INDIAN ROCK LAKE
FRANKLIN COUNTY, MISSOURI
MISSOURI INVENTORY NUMBER 31033

PHASE I INSPECTION REPORT
NATIONAL DAM SAFETY INSPECTION

PREPARED BY: ST. LOUIS DISTRICT CORPS OF ENGINEERS
FOR: GOVERNOR OF MISSOURI
JULY 1978

PHOTO 2 Spillway cut through embankment

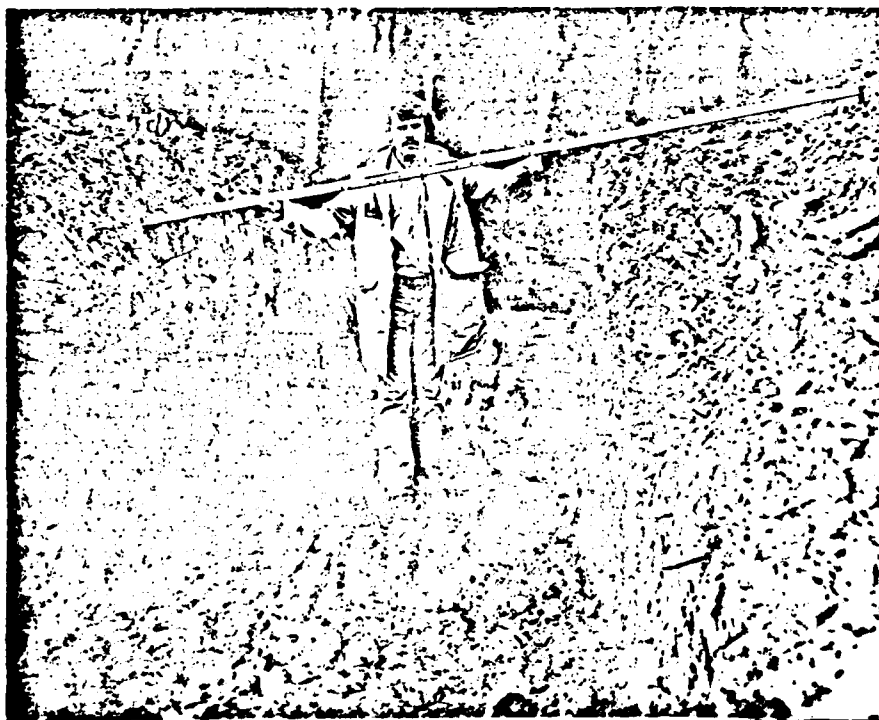
An unprotected 6-foot by 6-foot outlet cut through the embankment as an emergency spillway indicated the dam is unzoned, or of homogeneous construction in the area exposed. Numerous roots were found in the fill material (see photo 2). These roots constitute a potential seepage hazard as they decay. Sidewalls of the cut were firm but the bottom was soft from flowing water. No erosion protection was provided. This earth cut could not be expected to remain intact during any prolonged flow. Significant embankment erosion, and possible failure, would likely occur.

(3) An unprotected 6 feet by 6 feet notch had recently been cut through the embankment near the left abutment to serve as an emergency spillway. The water flowing through the notch was cutting its own exit channel parallel to the toe of the dam to the creek. (See photos 2 and 3).

d. Provide an adequately sized and erosion resistant spillway and exit channel with proper energy dissipators.

PHOTO 3 Spillway discharge

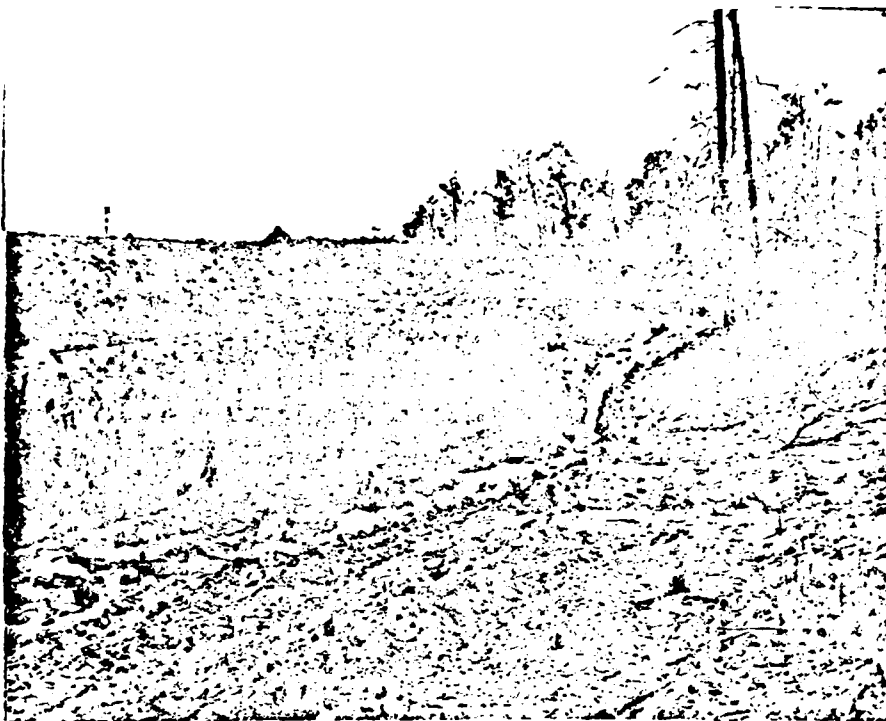
Approximately 5 cfs was flowing through the notch at the time of the inspection and that flow was eroding the exit channel. Any significant and sustained flows through the emergency spillway could cause excessive erosion of the embankment and the exit channel. The excessive erosions could threaten the safety of the dam.
